# 21 SUB2007-00202

## **NEW HOME SUBDIVISION**

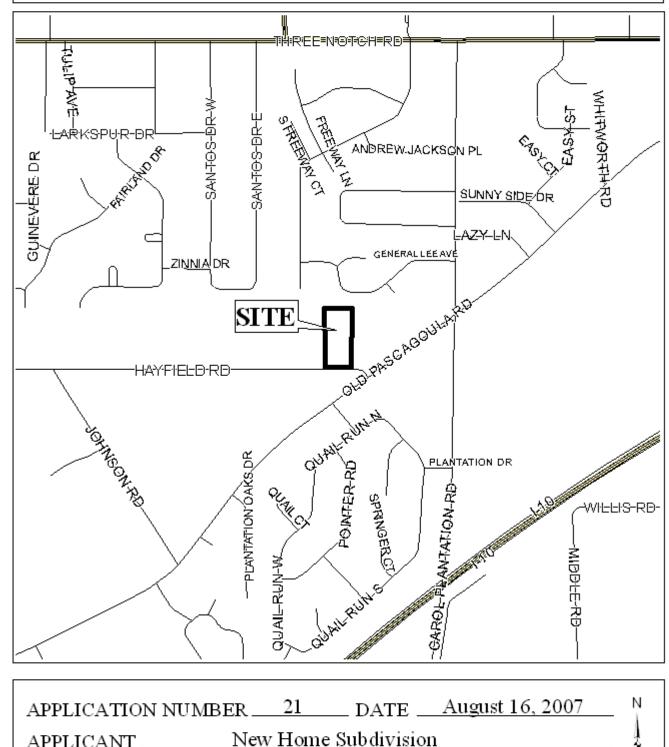
The site fronts on Hayfield Road, with a 50' right-of-way, and no dedication is required. As a means of access management, each lot should be limited to one curb cut to Hayfield Road, with the size, location, and design to be approved by the Mobile County Engineering Department.

The required 25' minimum building setback line is not shown but would be required on the final plat.

No lot sizes were indicated on the submitted plat; therefore, the plat should be revised to label each lot with its size in square footage, or there should be the provision of a table on the plat depicting the same information.

Since this site is in the County, a note should be placed on the final plat stating that any lots which are developed commercially and adjoin residentially developed property must provide a buffer in compliance with Section V.A.7. of the Subdivision Regulations.

The site is in the unincorporated part of Mobile County; nevertheless, development should be designed to comply with the stormwater detention and drainage facilities of the City of Mobile stormwater and flood control ordinances. Submission of certification from a licensed engineer certifying that the design complies with the stormwater detention and drainage facilities of the City of Mobile stormwater and flood control ordinances prior to the issuance of any permits should be required. Certification should be submitted to the Planning Section of Urban Development and County Engineering.

The plat meets the minimum requirements of the Subdivision Regulations and is recommended for Tentative Approval, subject to the following conditions:

- 1) placement of a note on the final plat stating that each lot is limited to one curb cut to Hayfield Road, with the size, location, and design to be approved by the Mobile County Engineering Department;

- 2) depiction of the 25' minimum building setback line along Hayfield Road;
- 3) revision of the plat to label each lot with its size in square feet, or provision of a table on the plat depicting the same information.

- 4) placement of a note on the Final Plat stating that any lots which are developed commercially and adjoin residentially developed property must provide a buffer, in compliance with Section V.A.7. of the Subdivision Regulations; and

- 5) placement of a note on the Final Plat stating that development will be designed to comply with the stormwater detention and drainage facilities of the City of Mobile stormwater and flood control ordinances, and requiring submission of certification from a licensed engineer certifying that the design complies with the stormwater detention and drainage facilities of the City of Mobile stormwater and flood control ordinances prior to the issuance of any permits. Certification to be submitted to the Planning Section of Urban Development and County Engineering.
